March 26, 1989

Re: Work Plan for further site investigation, ARCO Station #374,
6407 Telegraph Avenue, Oakland, California.

GENERALIZED SITE PLAN
ARCO Station No. 374
Telegraph and Alcatraz Avenues
Oakland, California

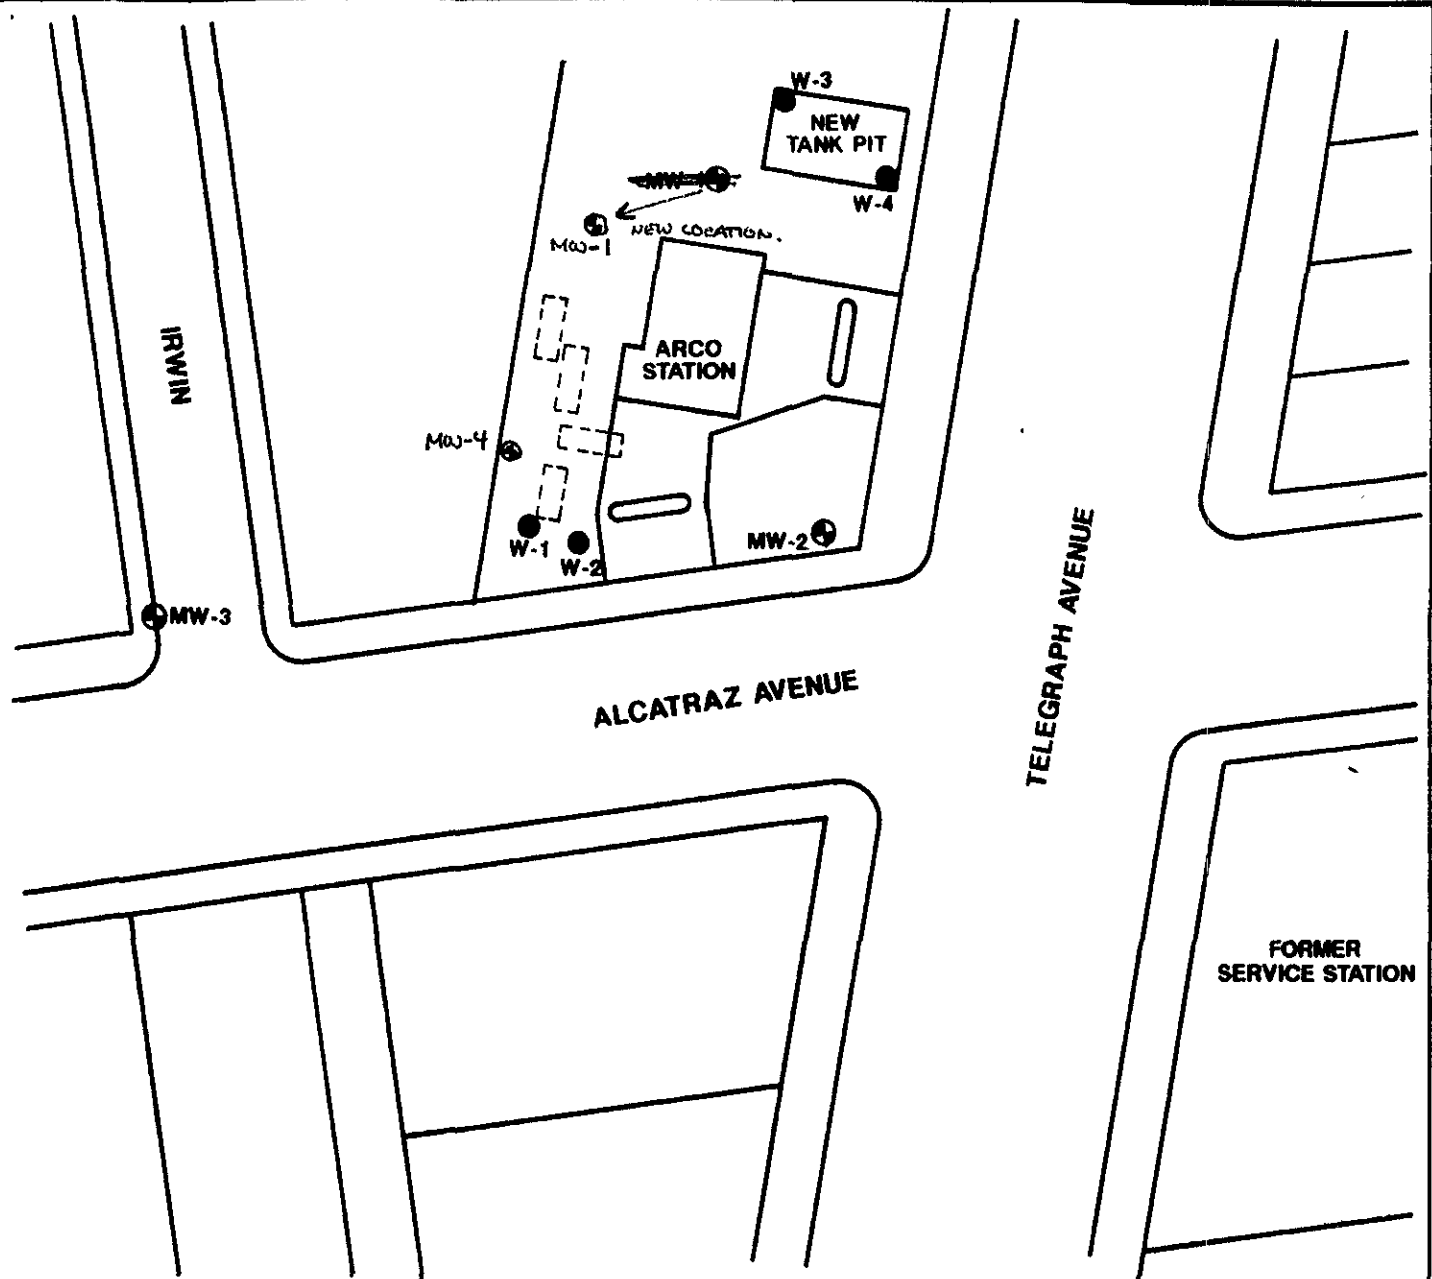
1) Vertical extent of unsaturated soil contamination will be performed by drilling soil borings at the locations shown on attachment A. The borings located near Alcatraz Avenue will be drilled by a hand-held auger machine due to the presence of high voltage lines overhead. Soil samples will be analyzed for TPH_{gasoline} and BETX compounds at 5-foot intervals above the water table by laboratory analyses specified in the RWQCB staff recommendations.
